RECEIPT DATE: 2/2/15 **ONSITE SEWAGE DISPOSAL SYSTEM** P 555729

PROPERTY ADDRESS: 2034 Drovers Lane
 SUBDIVISION: Vista Ridge LOT: 10 TAX ID: 04-595475
 CONTRACTOR: Fogle's Septic Clean Inc. EMAIL: kevin@foglesinc.com
 CONTRACTOR ADDRESS: 580 Obrecht Road, Sykesville, MD 21784 PHONE: 410-795-5670
 PROPERTY OWNER: DR Horton EMAIL: _____
 OWNER ADDRESS: 1356 Beverly Road, McLean, VA 22101 PHONE: 571-723-0813

WALL CHECK
VISTA RIDGE
PLAT No. 22432
LOT No. 10

From: John Carney <jcarney@bei-civilengineering.com >
Sent: Thursday, February 26, 2015 3:30 PM
To: Wolf, Kevin
Subject: RE: 2034 Drovers Lane Vista Ridge Lot 10

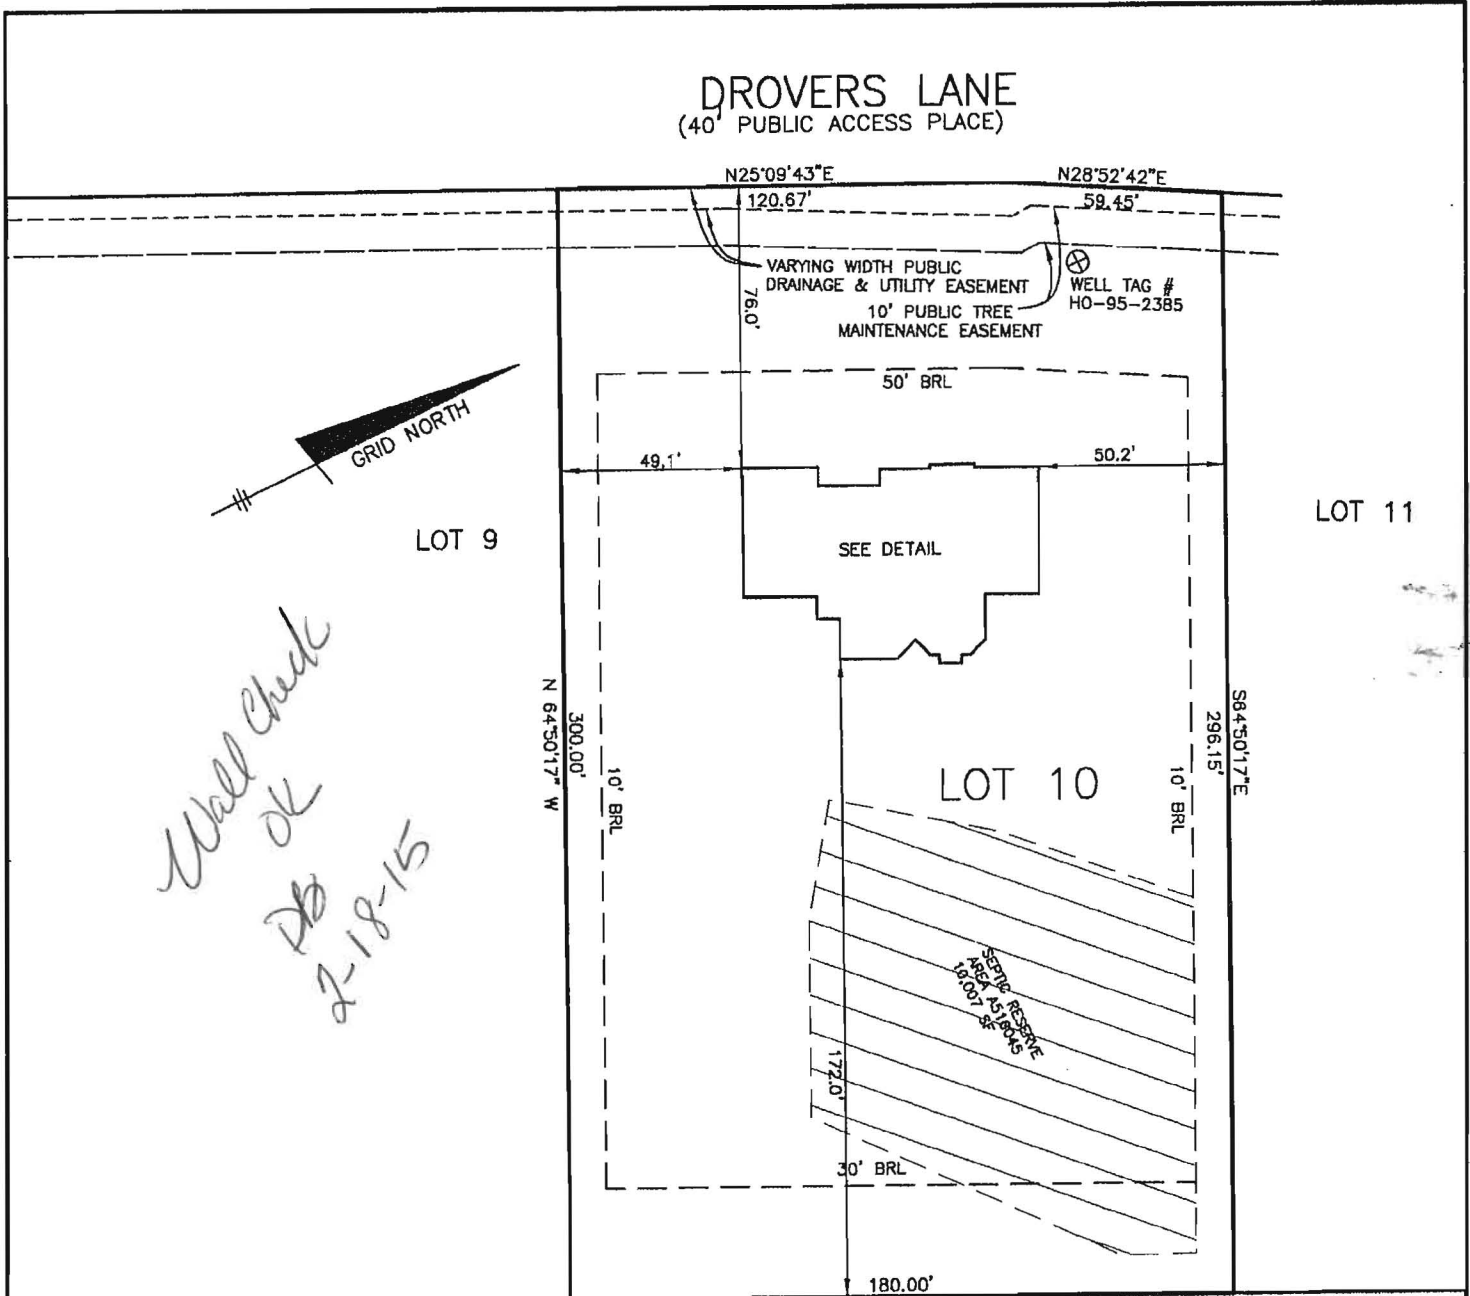
TRENCHES:	LINEAR FEET REQUIRED: <u>158 206'</u>	INLET DEPTH: <u>4'</u>
	TRENCH WIDTH: <u>3'2'</u>	MAXIMUM BOTTOM DEPTH: <u>9'</u>
	MINIMUM SPACE BETWEEN TRENCHES: <u>10'</u>	EFFECTIVE AREA BEGINNING DEPTH: <u>6'</u>
LOCATION:	PER APPROVED SITE PLAN. SEWAGE DISPOSAL AREA AND BAT UNIT LOCATION MUST BE STAKED BY LICENSED SURVEYOR PRIOR TO PRE-CONSTRUCTION INSPECTION.	
NOTES:	Install BAT Unit per plan. $5 \text{ BR} \times 150 \text{ GPD} = 937.5 \text{ ft}^2 \div 2 \text{ ft wide} = 469' \text{ total length}$ $\times 0.44 \text{ sidewall credit} = \boxed{206' \text{ total}}$

SEWER PROFILE - LOT 10
SCALE: VERTICAL 1"=3', HORIZONTAL 1"=30'

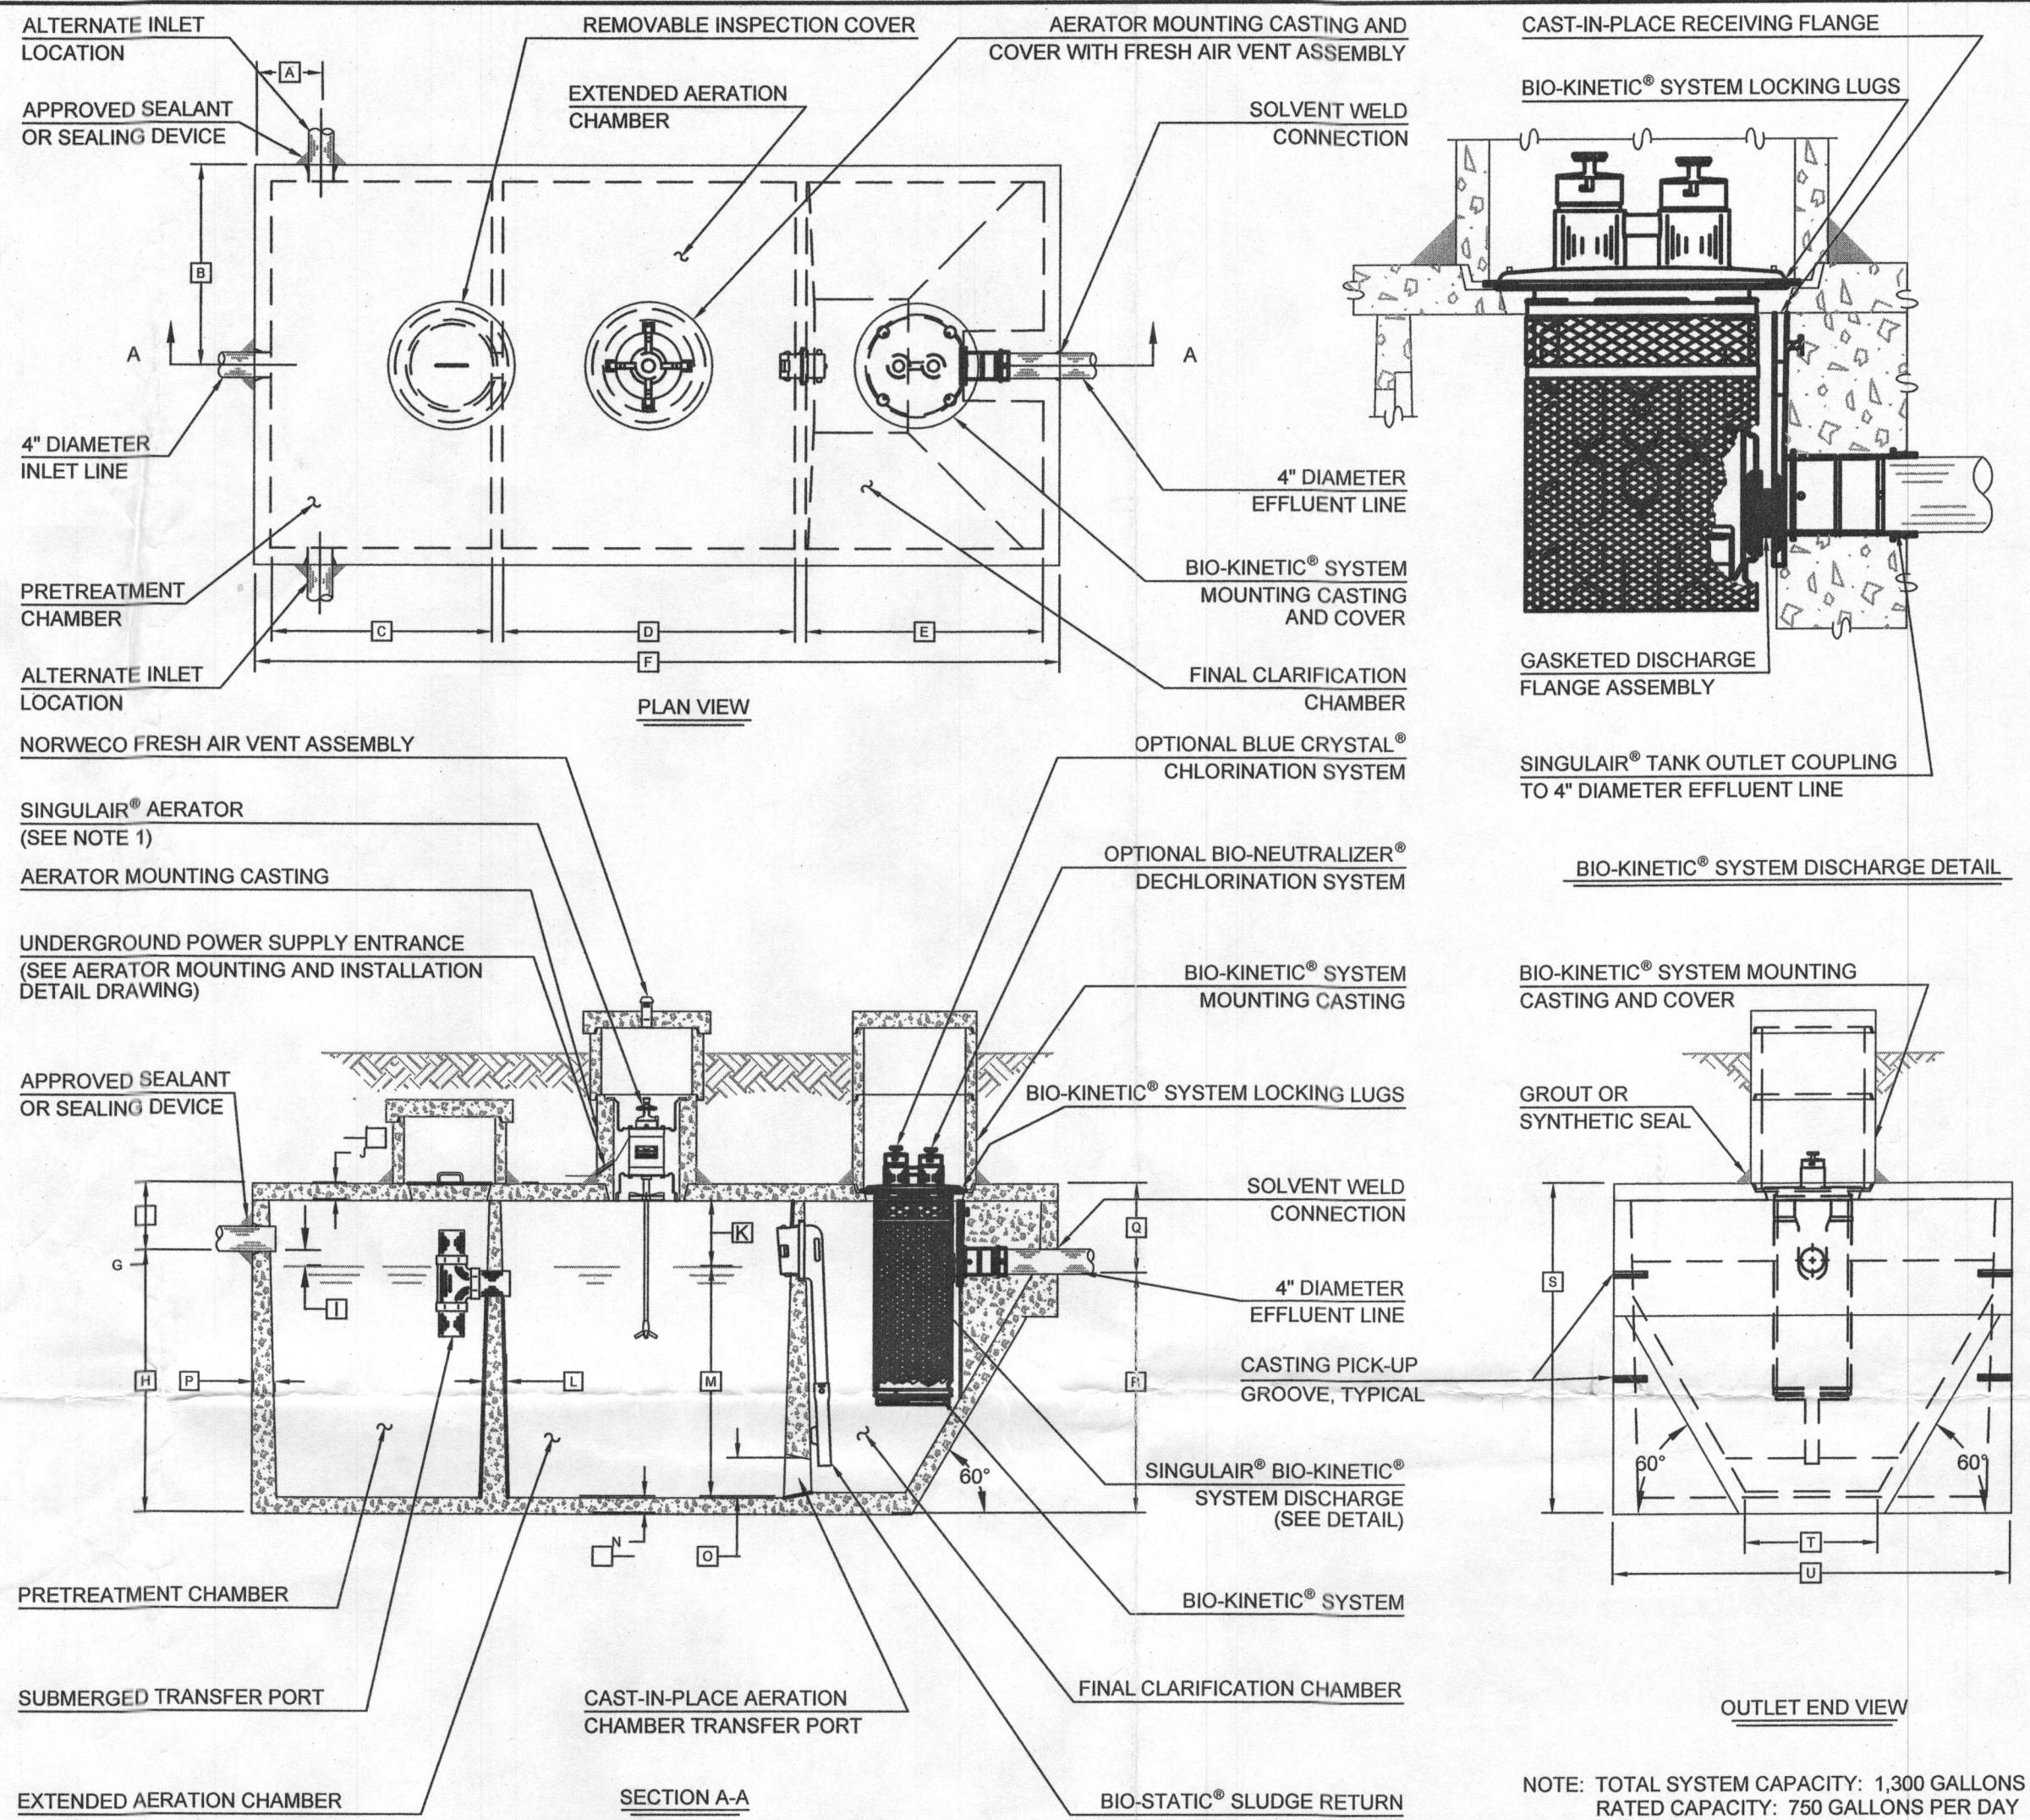
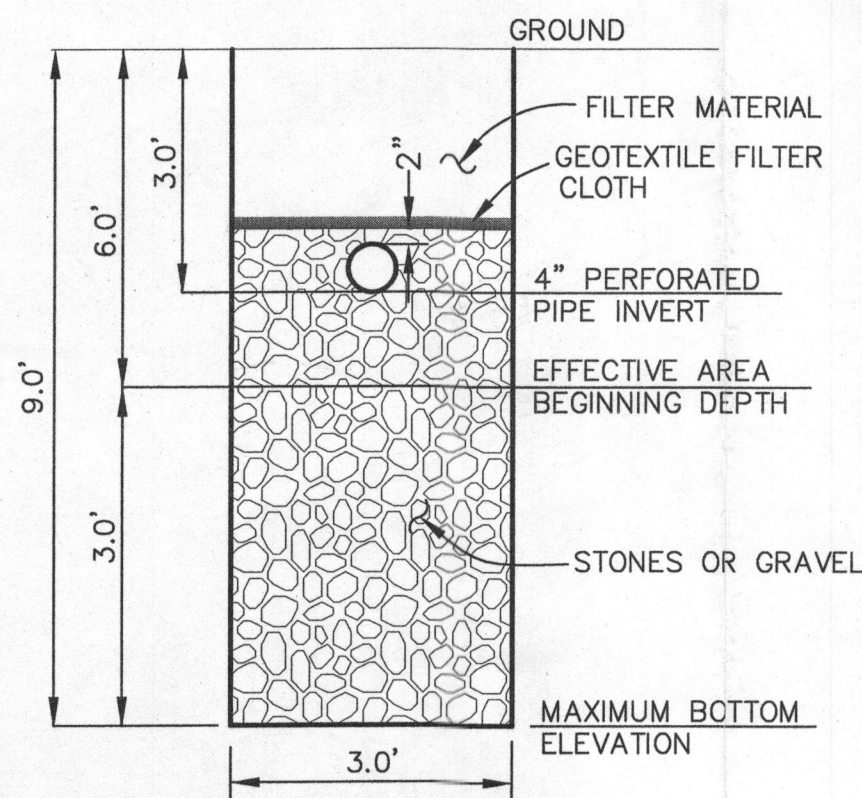
John,
Here are the new trench specs: **INLET = 4' below grade, BOTTOM = 9' below grade, EFF AREA = 6' below grade, TRENCH WIDTH = 2' wide, SPACING = 10'**
We laid out 4 trenches totaling 205' or 4x51' trenches running in both directions. Contour runs pretty much as shown on the plan. Just ADD trench 2-1 into the initial system design and show the 2nd replacement system the same, placed below the initial 4x51' trenches.

Kevin, It looks like they might be able to run a 1% outfall down to the 428 contour and put in a pump tank. The BAT site plan and profile would have to be revised and a pump selected.

I am not sure if you know this or not, we were onsite today with Fogle's for a pre-construction meeting to lay the septic system out when we encountered a problem. They brought the house sewer under the footer. After an extensive site evaluation (determining elevations, grades, slopes, pipe inverts, etc...) we could not get the grade to work with the existing invert @ the house as installed. The plan (BAT site plan) for this particular property was approved with 'hung' sewer. I explained this to the super intendant on site and he said he would get in touch with you. The site does not slope much (about 4% or so) but they may be able to move the tank all the way down near the end of the lot at the bottom of the SRA. The house looks almost complete. Let me know what you come up with or if you need me to advise. Oh and the BAT unit proposed was the Norweco but they may change as a pump tank will be needed, possibly a Hoot. I also have the revised trench spec's too if you need them.

Kevin, Seems like they are going to fix it to be per plan. No need for a pump. John
